Intel[®] 82576EB Gigabit Ethernet Controller Specification Update

LAN Access Division (LAD)

**Revision 2.9
June 2014**

Figure 1. Example With Identifying Marks

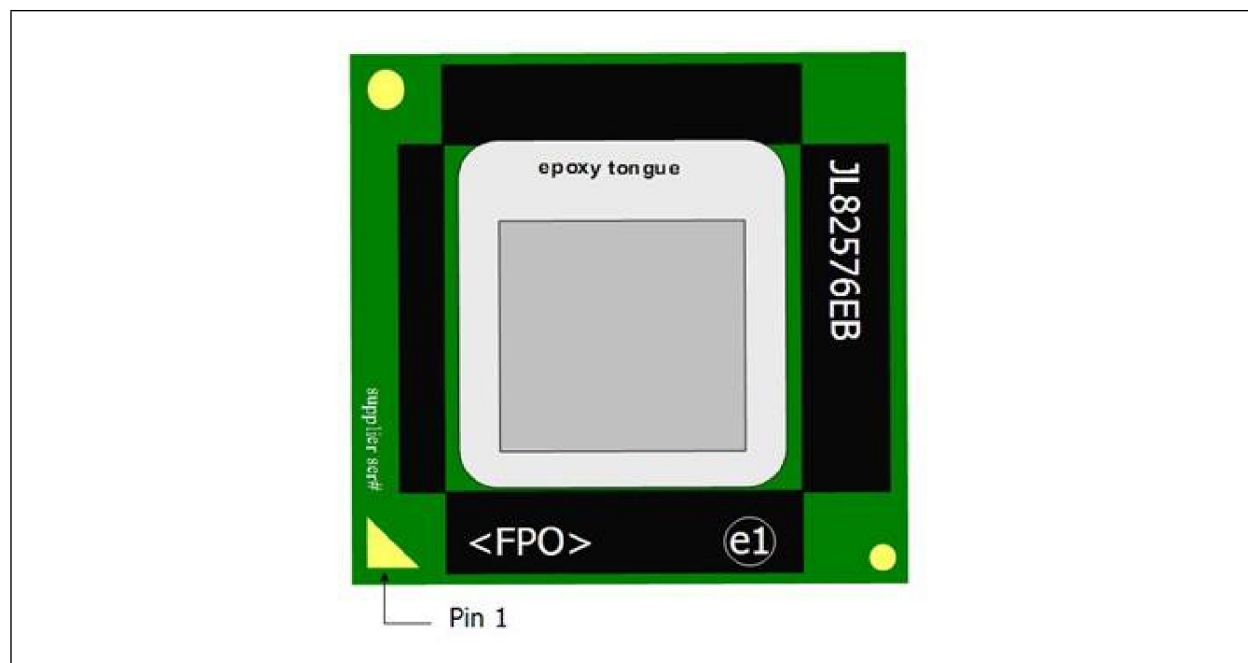
Lead-free parts will have “JL” as the prefix for the product code (vs. “HL”).

The devices can also have a “GB” marking, instead of “EB”. These are functionally equivalent and only used on Intel network interface adapters.

There is an internal designator visible as a dash on the die side of some packages. It’s location may differ. The mark (looks like a dash, approximately 300X1000 µm in size) does not impact function.
